### INTER-OFFICE MEMO

Agenda Items B.6 & H.6, January 14, 2019 Regular Council - Public

Hearing (By-law Nos. 19751, 19752 & 19753) Rezoning Application No. 7914-0261-00

8205 King George Boulevard

Appendix A - Previously proposed OCP Amendment map

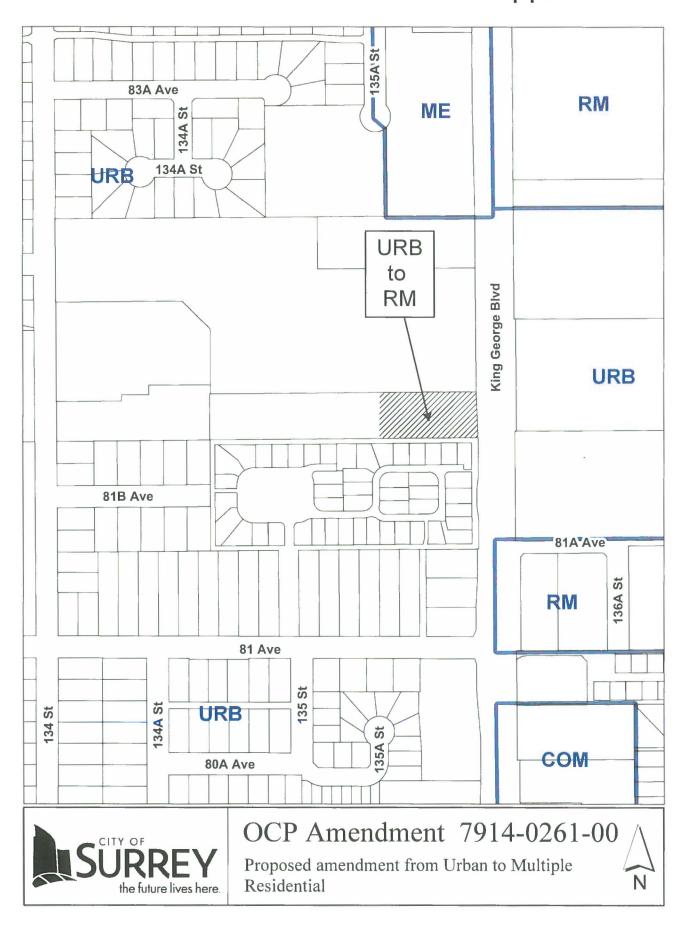
The planning report for Development Application No. 7914-0261-00 was considered by Council at its Land Use meeting on December 17, 2018. The report identified the need to amend the Official Community Plan ("OCP") to redesignate a portion of the site from Urban to Multiple Residential, to permit the development of approximately 34 townhouse units and 78 apartment units (Appendix A). The report stated that only the apartment site needed to be redesignated to Multiple Residential, when in fact, the entire site, including the townhouse portion, needs to be redesignated to Multiple Residential.

Townhouse projects with densities of up to 30 units per acre ("upa") are permitted within the OCP's Urban land use designation, but only if the subject site is located in a secondary plan area, (for instance, within a Neighbourhood Concept Plan area). The subject property is not located in a secondary plan area, and therefore, may only allow townhouse projects with a density of up to 15 upa. The density of the proposed townhouse project is 23 upa; therefore, the OCP designation also needs to be amended for the townhouse portion of the site from Urban to Multiple Residential, as shown in Appendix B.

In light of the above, OCP Amendment By-law No. 19751 is not in order as currently proposed, and needs to be revised so that the <u>entire</u> site is redesignated from Urban to Multiple Residential. Consequently, the Planning & Development Department recommends that:

- OCP Amendment By-law No. 19751 be revised so that the entire site is redesignated from Urban to Multiple Residential as shown in Appendix B, and that the bylaw be reconsidered for second reading, as amended, and a date for a Public Hearing be set for the amended OCP Amendment By-law No. 19751; and
- To minimize inconvenience to the public, that the Public Hearing for Rezoning By-law Nos. 19752 and 19753 proceed as scheduled tonight (January 14, 2019), but to withhold consideration of Third Reading of these by-laws until such time as Third Reading for all three by-laws (rezoning and OCP amendment) can be considered concurrently by Council at the same Council meeting.
